Submissions Report

Western Riverina Quarry

October 2022

Figure 1
LAND OWNERSHIP, SURROUNDING
RESIDENCES AND GROUNDWATER BORES

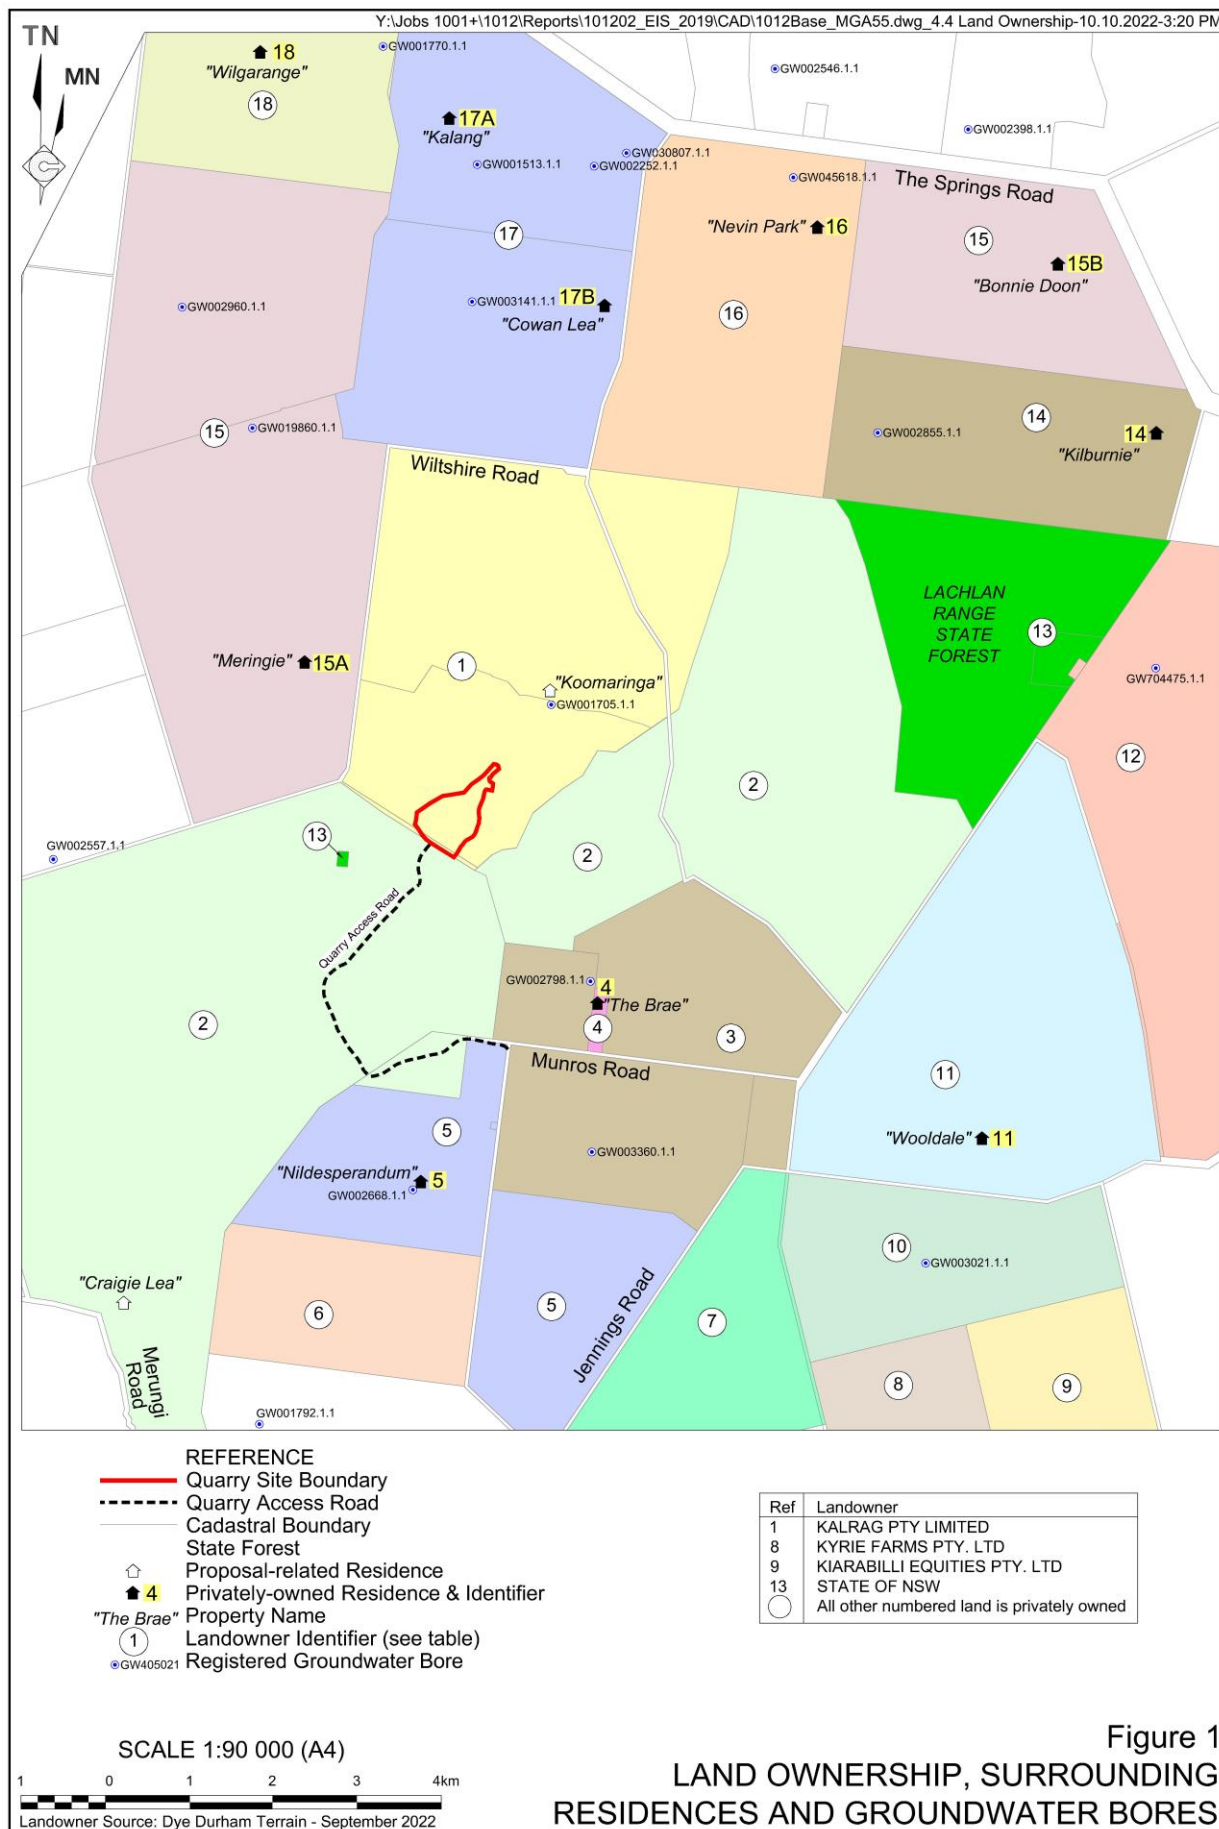
Council records indicate that all of Lot 2 DP821515, Part of Lot 1 DP755180 and all of Lot 29 DP751727 is owned by a private owner, whereas, page 4-8 of your EIS indicates that these lots are still owned by "State of NSW - State Forrest". Please clarify and amend this ownership detail page.

An updated version of Figure 4.4 from the EIS presenting updated land ownership information is provided as **Figure 1**. It is noted that Lot 2 DP821515 was subdivided following the submission of the EIS and now comprises Lots 11 and 12 DP1286927.

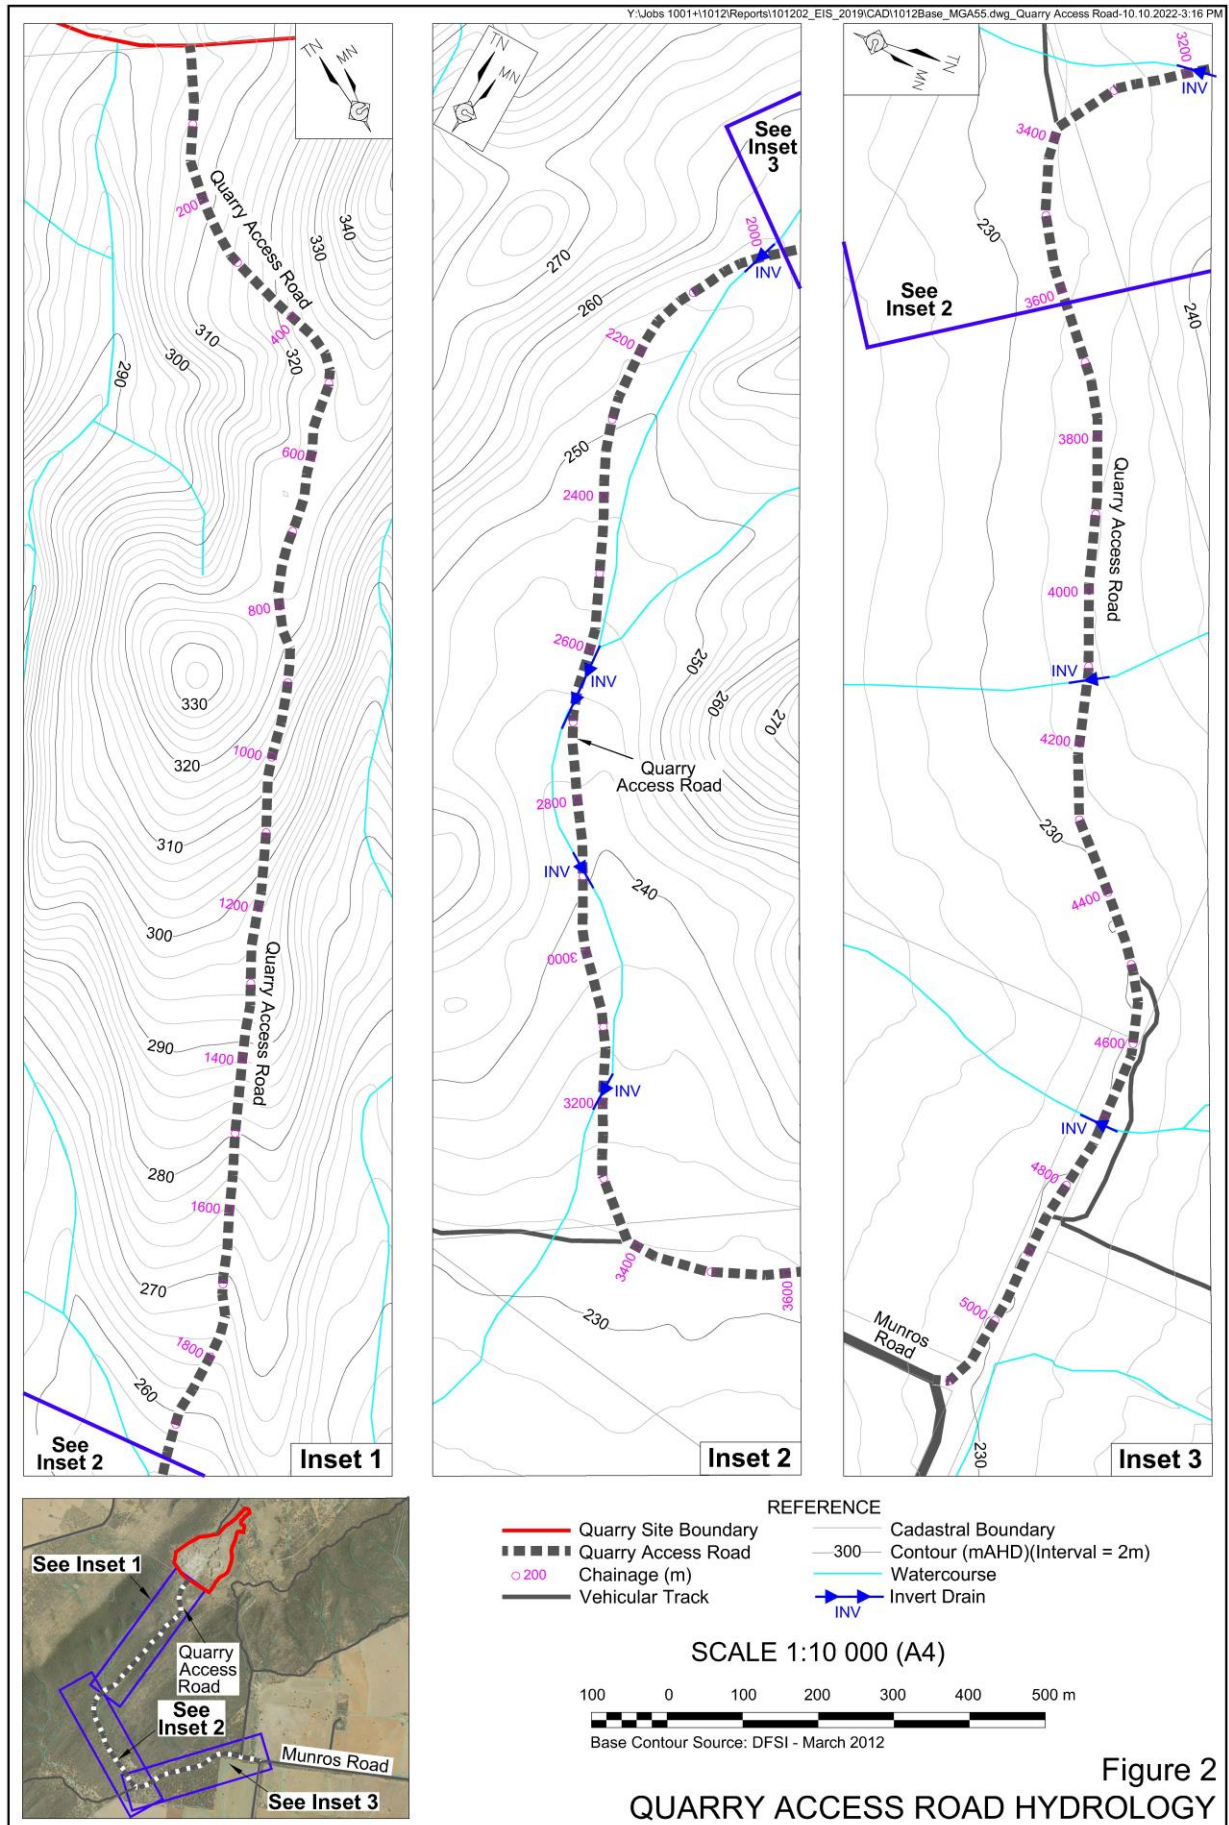
In recent times there has been work done on this access road that, in my opinion, interferes with the natural flow of these watercourses that may impact my property in the future.

Figure 2 presents the Quarry Access Road and its hydrological context. It is acknowledged that several non-perennial watercourses cross the Quarry Access Road with a total of six crossings identified. The Applicant proposes to construct inverts at each crossing to ensure adequate cross drainage and the maintenance of flow regimes. Inverts would be constructed with the finished surface at, or just below, the level of the existing stream bed. It is anticipated that the inverts would be filled with granular material to provide a trafficable surface.

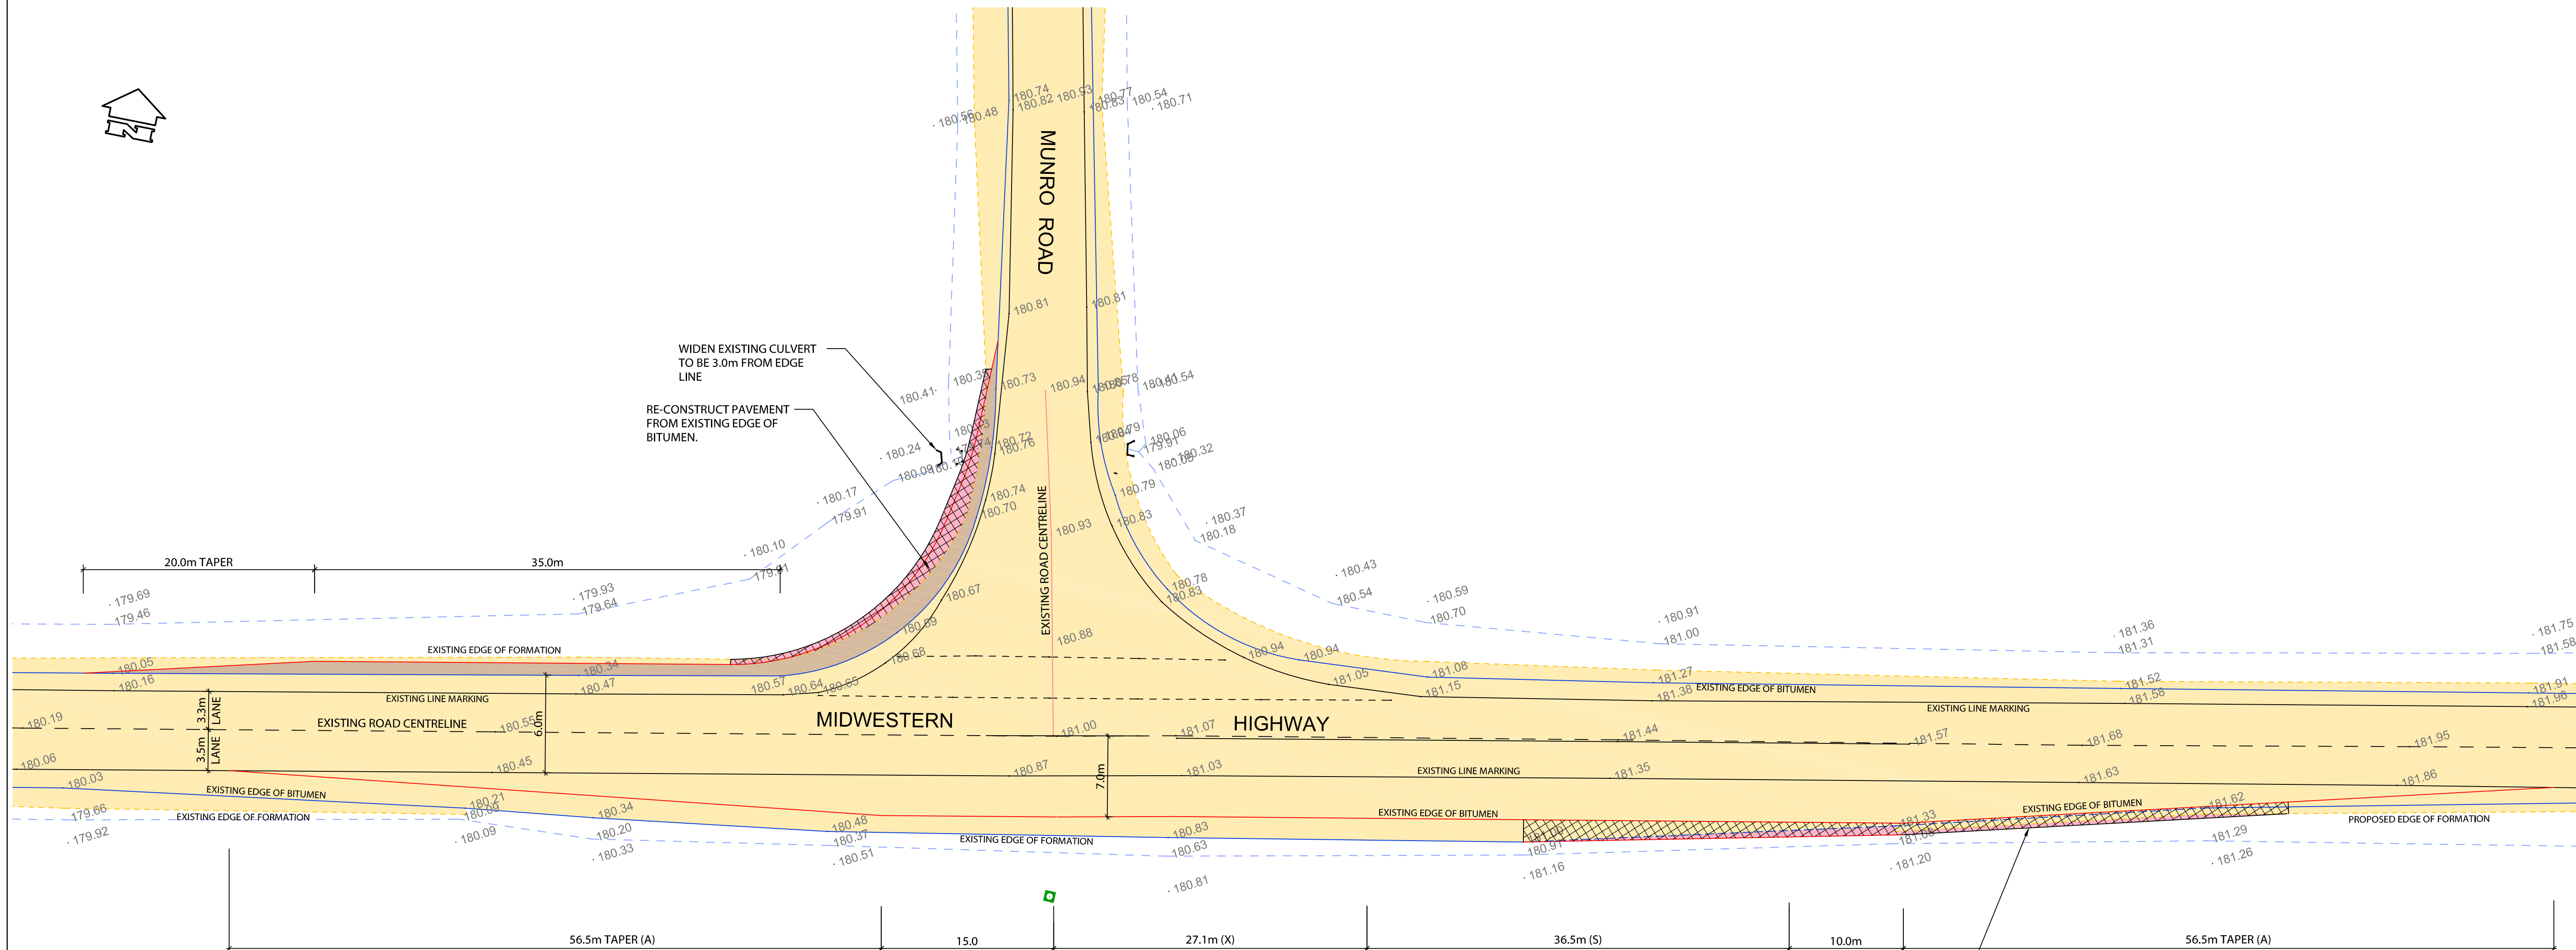
Have the applicant certify that the intersection of Mid Western Highway and Munros Road is compliant with the general minimum preferred treatment for rural road intersections, being a Basic Auxiliary Left (BAL) and Basic Auxiliary Right (BAR) treatment, as per Austroads (2020b) warrants for greenfields rural intersection treatments? The certification must be by a suitably qualified person (i.e. civil design engineer) for the design speed (posted speed + 10km/h) as per Austroads Guide to Road Design for a Road Train Route.

An assessment of the intersection of the Mid Western Highway and Munros Road was undertaken by Mr Grant Dowling of JME Civil Pty Ltd. This assessment identified that minor works would be required to seal and widen the left-in bend from the Mid Western Highway to Munros Road. Indicative drawings are provided as **Appendix 1**.

The Applicant commits to undertaking these intersection upgrade works should approval be granted.
